November 22, 1993

HLA Project No. 20875-4.18

Reference: Evaluation of Stabilization To Date and
Response to EPA's Request for
Additional Information
Pilot Study 4 & Active Area 1
Bailey Site

FIGURE 1. UC STRENGTH VS PERMEABILITY

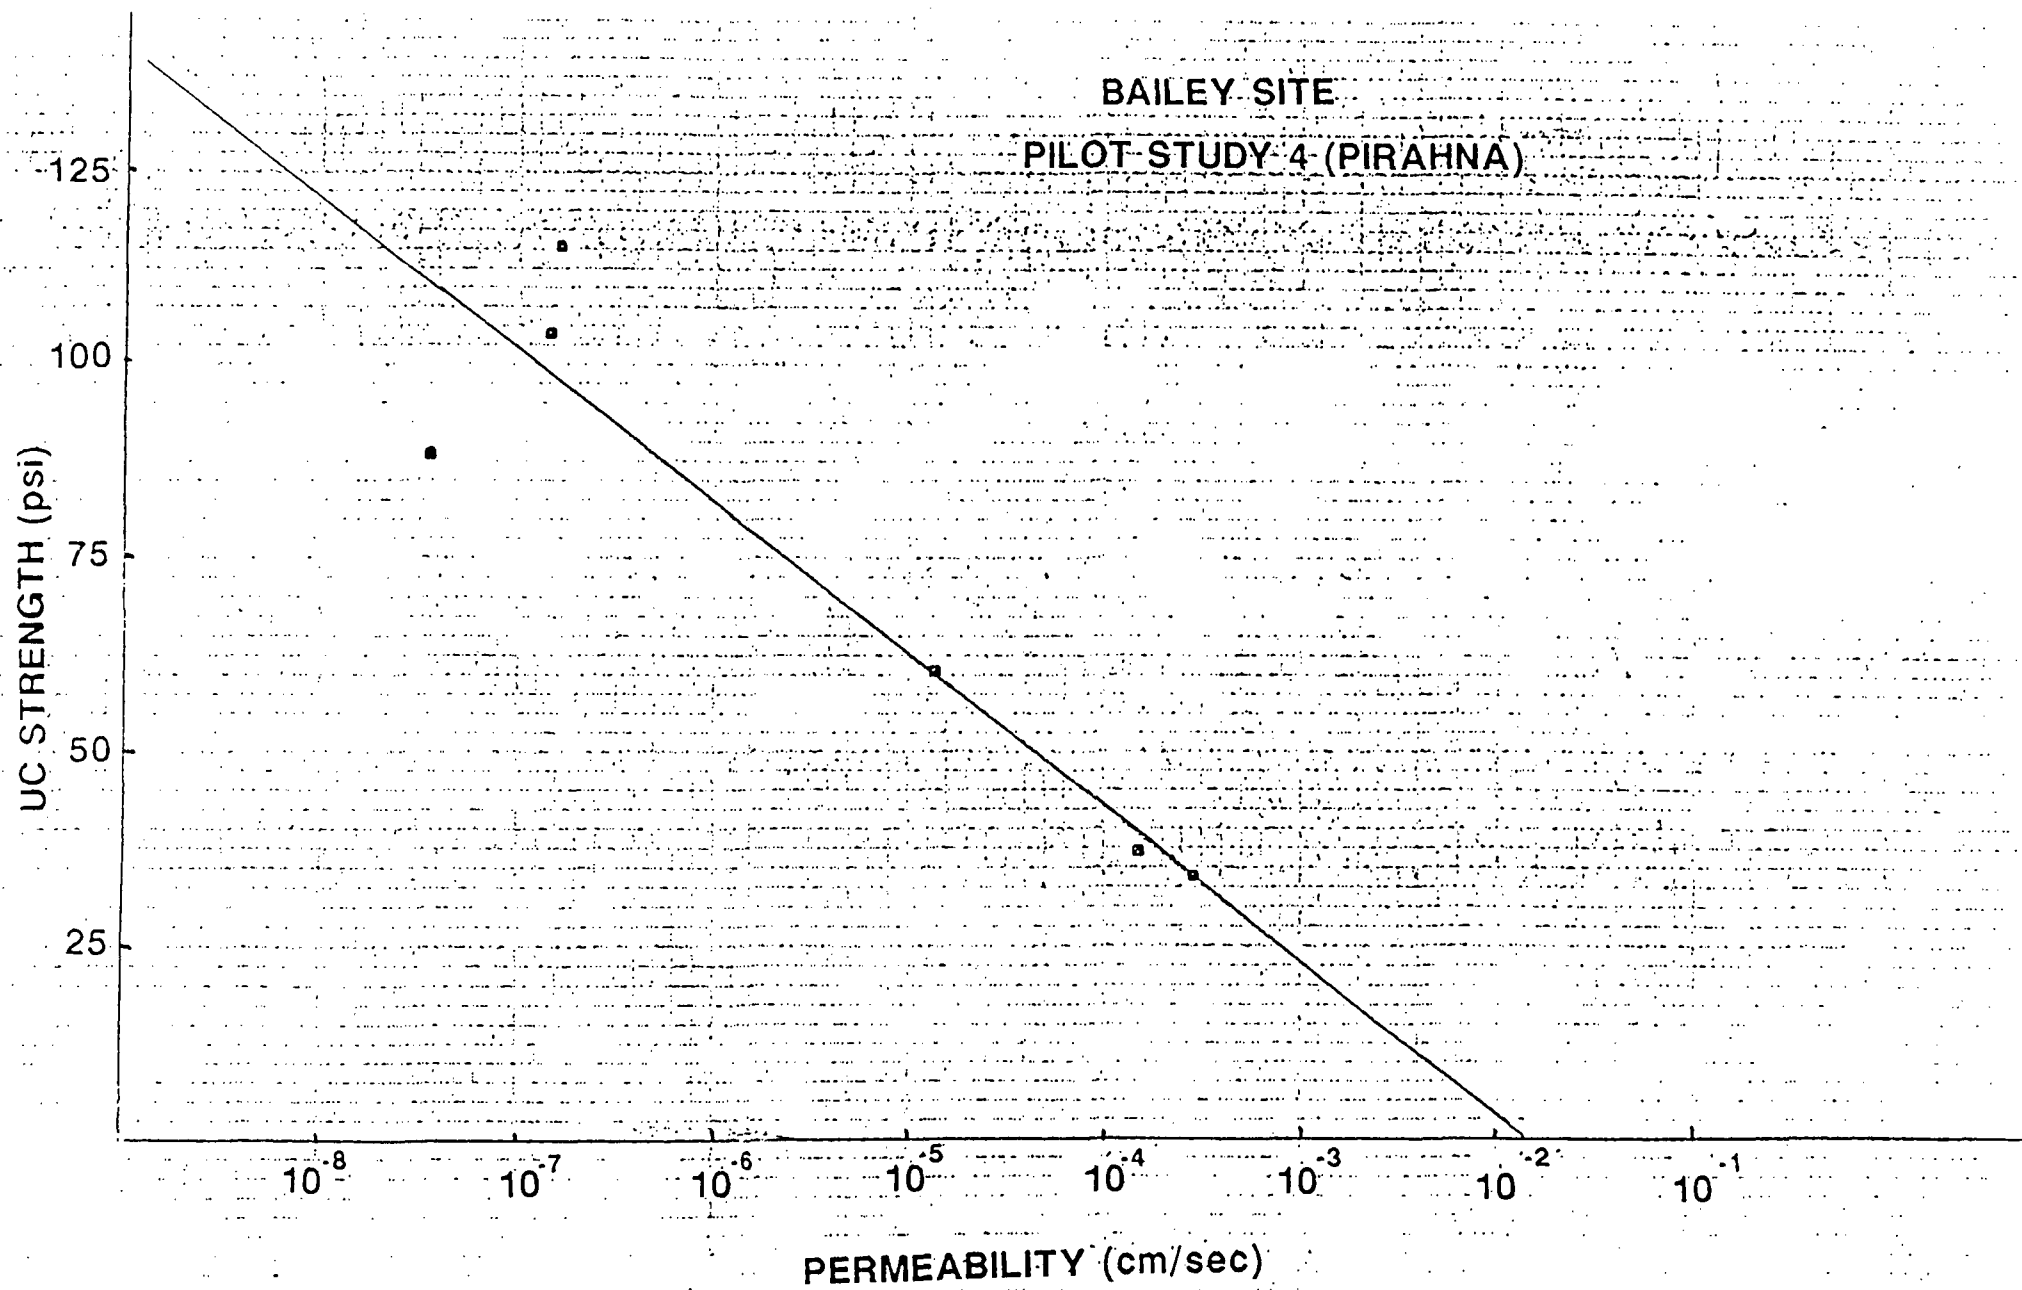
2) *Discuss any correlation between UC strength and the permeability analysis test results for the two sample locations (PS4-1, PS4-2).*

The UC strength/permeability correlation for PS4-1 and PS4-2 is plotted in Figure 1 (attached). A line of best fit has been drawn to show the approximate relationship. Even though there is scatter in the data, it indicates that the permeability decreases as the UC strength increases. According to this line, the average UC strength corresponding to the target permeability (1×10^{-6} cm/sec) is approximately 80 psi.

Two main variables that influence UC strength are the amount of cement added and the final density of the stabilized mass. We believe that the high cement content is the primary contributor to the high strength corresponding to the target permeability; however, it does not reduce the voids contained in the stabilized waste. Higher voids result in a less dense stabilized mass which can result in higher permeability.

We also evaluated permeability vs dry density, moisture content and void ratio; however, because of considerable scatter in the data, no meaningful relationships could be established. We believe this scatter is more likely indicative of variations in the mixing process than changes in the waste.
